Domtar A.W. LLC
285 Highway 71 South
Ashdown, AR 71822
870-898-2711

April 26, 2022

Re: Comments on the Proposed Arkansas Regional Haze Planning Period II State Implementation Plan

Figure 1. History of Bank Prime Rate, Aug. 8, 1983 to Mar. 17, 2022

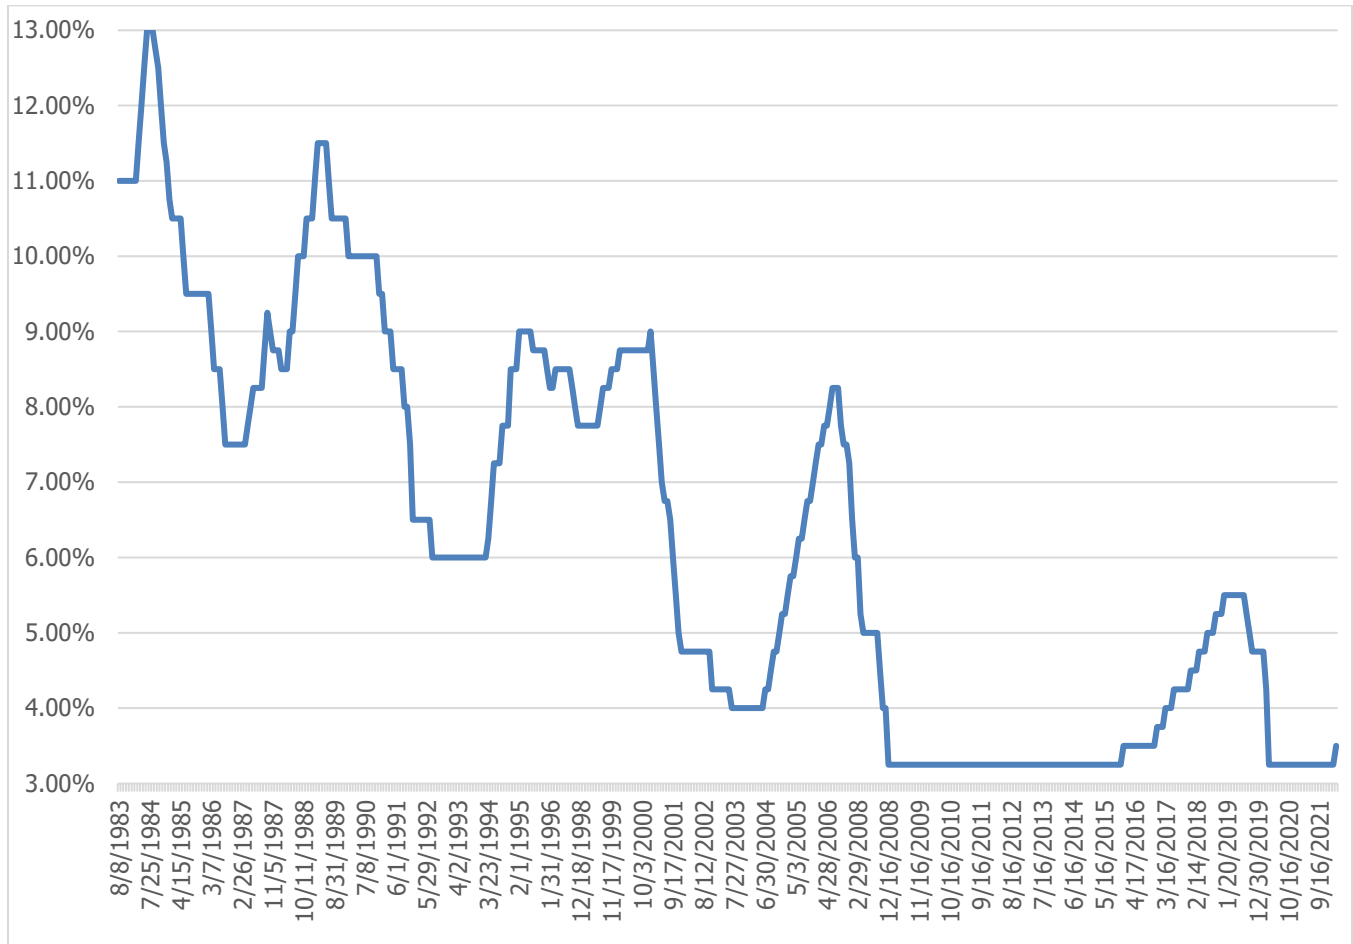
5. DEQ should not use 3.25 percent – the bank prime rate at the time of the SIP proposal – for the capital recovery calculations in the proposed SIP (at V-41 and other locations for other affected sources). Neither should it use 3.125 percent, which is an additional value used in DEQ’s spreadsheet in the proposed SIP, Appendix H. As discussed in the Texas Commission on Environmental Quality’s *Response to Comments Received Concerning the 2021 Regional Haze State Implementation Plan (SIP) Revision* (herein referred to as the “TCEQ RTC”), “[u]sing the bank prime rate in the four-factor analysis would not reflect **real** costs expected to be imposed on selected sources.” (TCEQ RTC at 23-24, emphasis added). Moreover, even if the bank prime rate were representative of actual costs in real time, there is no guarantee that it will not change before costs are realized several years in the future. As illustrated in Attachment 1, the bank prime rate has fluctuated significantly, and it has recently increased from 3.25 percent to 3.5 percent. Based on the history of the bank prime rate, the unprecedented amount of inflation in 2021 and 2022, and the current worldwide economic pressures, it is inappropriate to rely upon the bank prime rate for capital recovery calculations.

In its Control Cost Manual, EPA guides sources when performing a cost analysis, that it is important to use the nominal interest rate that the company faces and not a general interest rate, such as short-term prime. The base rates used by banks do not reflect entity- and project-specific characteristics and the credit risk of borrowers. As presented in the ICR Response (at 2-5, 2-6), Domtar’s capital projects group uses 10.5 percent as the weighted average cost of capital. As such, the 7 percent interest rate is a more appropriate rate (than the bank prime rate), and is very conservative, for assessing a capital project related to the installation of additional controls.

Figure 2. Year-by-Year (2000 – 2020) Observations of Visibility Conditions at Caney Creek on the 20 Percent Most Impaired Days and the 20 Clearest Days

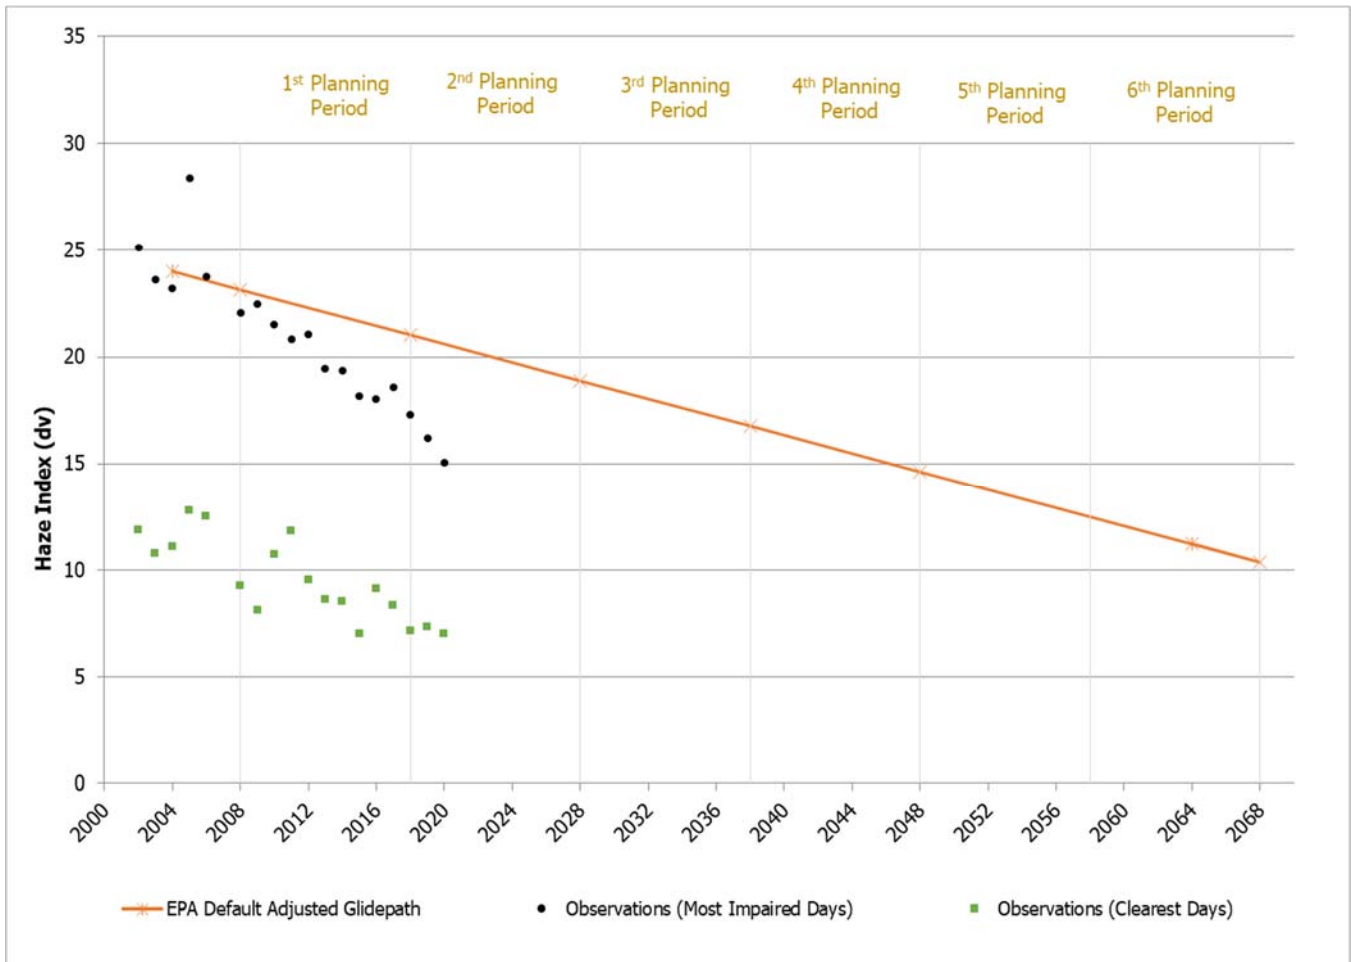
10. Domtar appreciates DEQ's documentation of the progress in visibility conditions at the two Arkansas Class I areas – Caney Creek and Upper Buffalo – from the start of the regional haze program through 2019 (proposed SIP at II-4, Table II-1 and Table II-2, at II-18, Table II-3 and Table II-4, and at IV-16, Table IV-3). Further, Domtar is providing in Attachment 2 updated versions of the four tables in proposed SIP section II. These updated versions consider the latest visibility data for 2020 that was made available to the Interagency Monitoring of Protected Visual Environments (IMPROVE) steering committee members on February 7, 2022.¹ Domtar is also providing in Attachment 3 two figures that graphically present the trends in visibility conditions at the Class I areas through 2020 (these figures present the same information, but in a different format and with 2020 data, as provided in the proposed SIP at II-5, Figure II-2, at II-6, Figure II-3, at II-19, Figure II-14, and at II-20, Figure II-15). Domtar has not undertaken an effort to update the other figures in the proposed SIP with 2020 visibility information or to verify the information presented by the DEQ based on its own modeling or the modeling conducted by the Visibility Improvement - State and Tribal Association of the Southeast (VISTAS).
